ADDENDUM 1 TO ENVIRONMENTAL IMPACT REPORT

Date of Publication of Addendum: October 10, 2024
Date of EIR Certification: September 5, 2019
EIR Case No. **2015-014028ENV**
Project Title: **3333 California Street Mixed-Use Project**
Modified Project Case No.: **2015-014028ENV-02**
Block/Lot: 1032/003
Project Sponsor: Don Bragg, Laurel Heights Partners, LLC
(415) 857-9324
Lead Agency: San Francisco Planning Department
Staff Contact: Debra Dwyer – (628) 652-7576
debra.dwyer@sfgov.org

Figure 3. Proposed Site Access - Approved Project

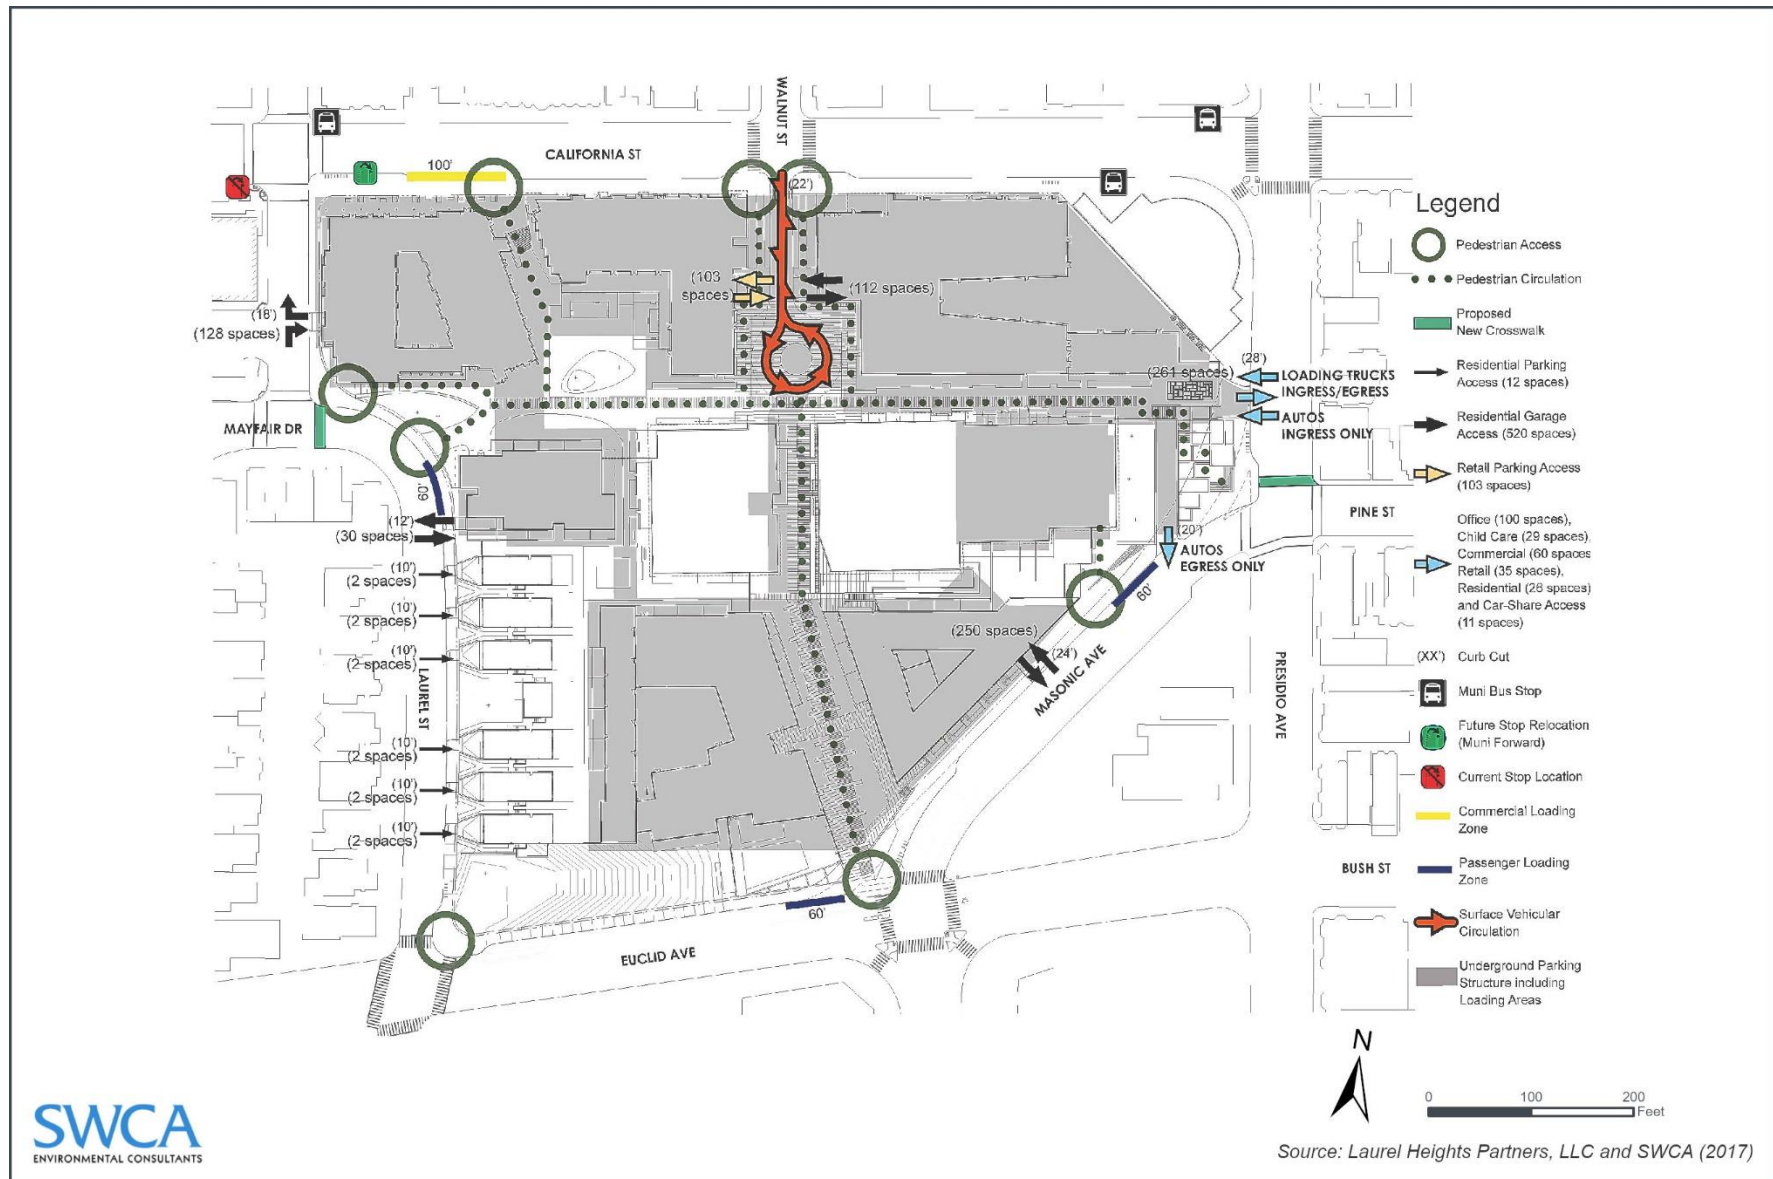
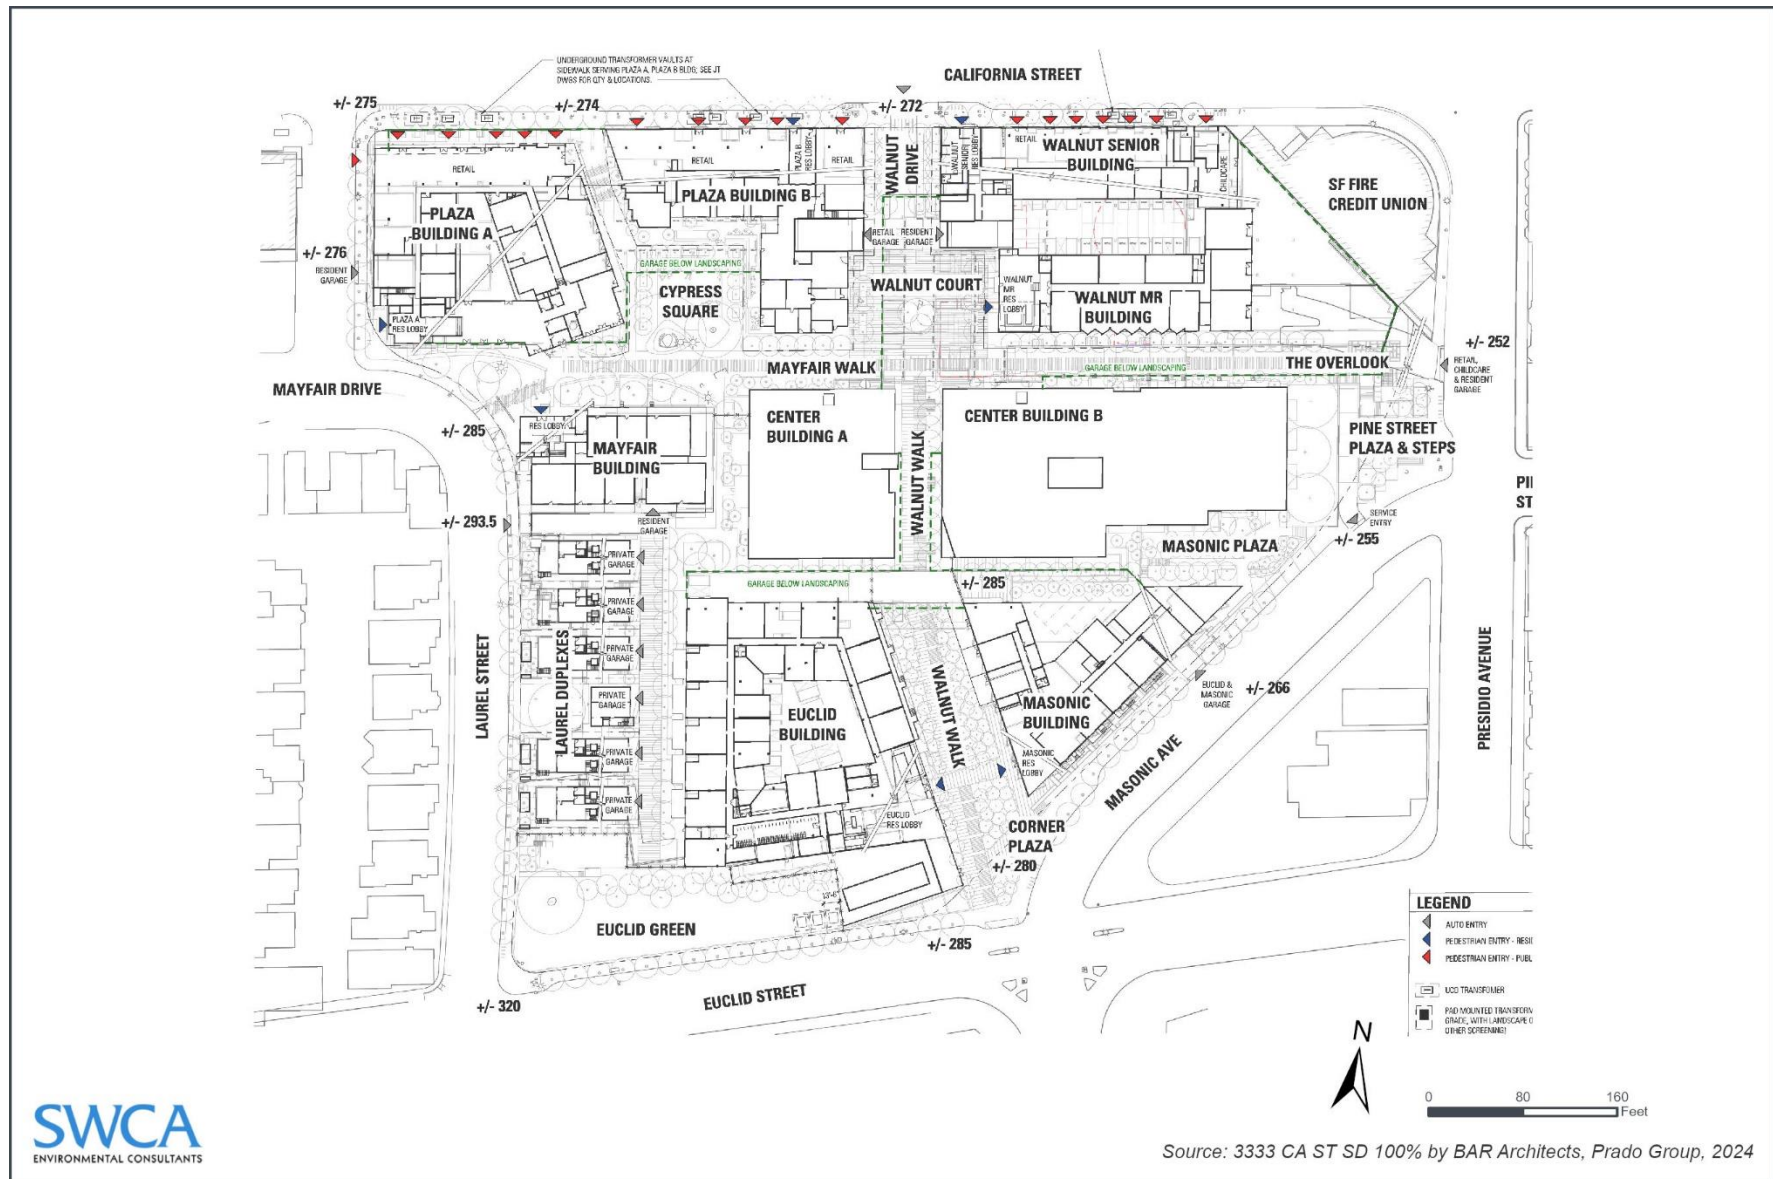
Under the modified project, the proposed off-street parking garage layouts for the California Street, Masonic Avenue, and Laurel Street/Mayfair Drive garages would be slightly different than those assumed for the approved project. Under the modified project on-street commercial and passenger loading zone locations and widths would be essentially the same as the approved project as would the curb cuts and

driveway locations for entry and exit to the off-street garages (see **Figure 3: Proposed Site Access - Approved Project**, p. 13, **Figure 4a: Proposed Site Access - Modified Project**, p. 14, and **Figure 4b: Proposed Site Access - Modified Project**, p. 15).

Figure 5. Preliminary Construction Phasing Diagram - Approved Project

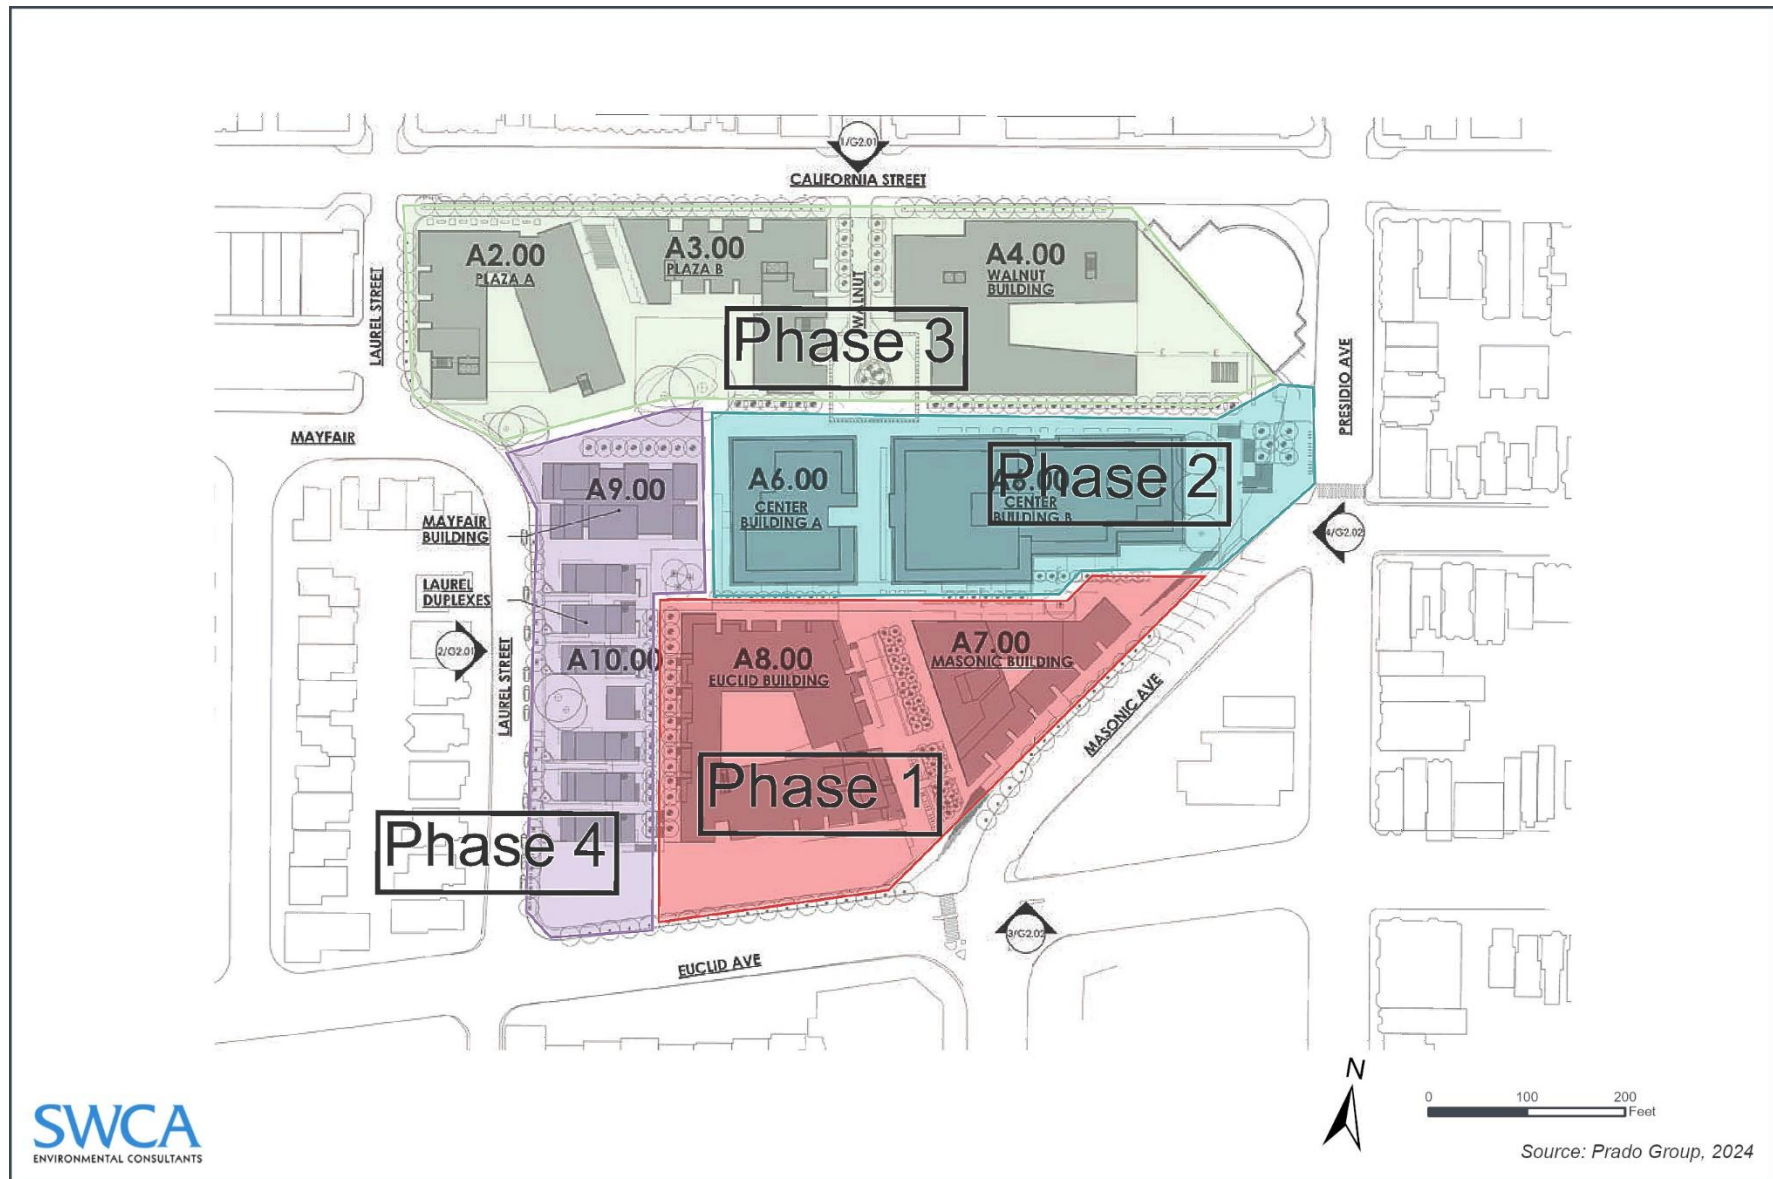
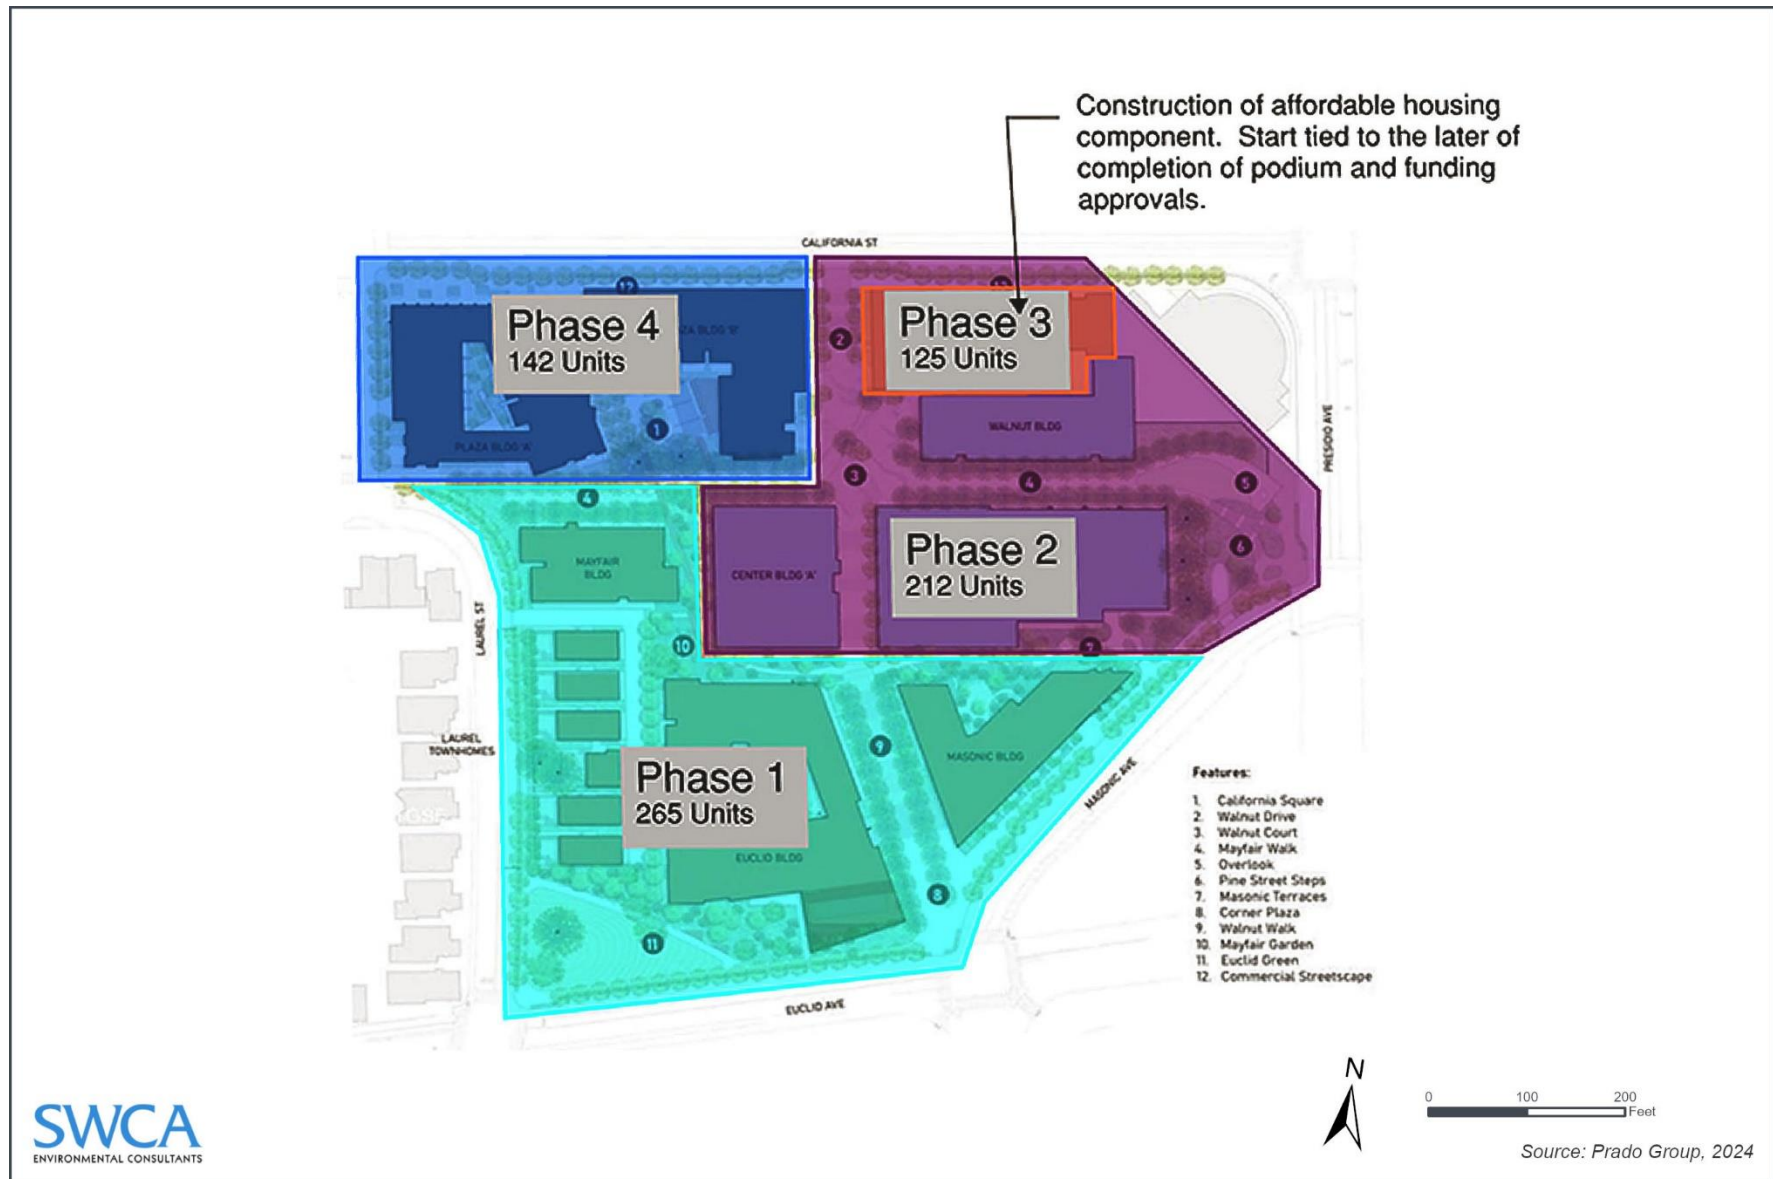
Full-build out under the modified project would be expected in five years, rather than in seven years as described and analyzed in the EIR for the most conservative CEQA analysis. As shown in **Table 3**, p. 9, the preliminary construction schedule under the modified project assumes spring 2025 as the start of construction and spring 2030 as the end of construction. As shown in **Figure 5: Preliminary Construction Phasing Diagram - Approved Project** and **Figure 6: Preliminary Construction Phasing Diagram - Modified Project**, pp. 16 and 17, construction activities for the four development phases would be modified to develop a larger proportion of the residential component of the overall development program more expeditiously (i.e., more housing units earlier). Like the approved project the proposed development program would also be constructed over four overlapping construction phases but with minor modifications. Site redevelopment under the modified project is listed below Mayfair Building and Laurel Duplexes with Phase 1, as modified, rather than Phase 4, as approved; and Walnut Building (the market rate component) with Phase 2, as modified, rather than Phase 3, as approved.

For the modified project, construction would continue to be sequenced over four development phases but would be developed over five years rather than seven years for the approved project (see **Table 3**, **Figure 5**, and **Figure 6**, pp. 9, 16 and 17, respectively). Further changes would include a slight re-ordering of the components of each of the four development phases, i.e. the Laurel Duplexes and Mayfair Building would shift from Phase 4 under approved project to Phase 1 under modified project. There would be limited changes to the site preparation, demolition, and excavation program. Most other important project features such as number and location of emergency diesel generators and equipment associated with heating ventilation air conditioning (HVAC) systems would also be essentially the same although in slightly different locations due to level-by-level and floor-by-floor refinements to the residential, retail, and childcare uses and to off-street parking layouts. The *2024 Updated Phasing Project Air Quality and Noise Analysis Results* are available for review.⁷
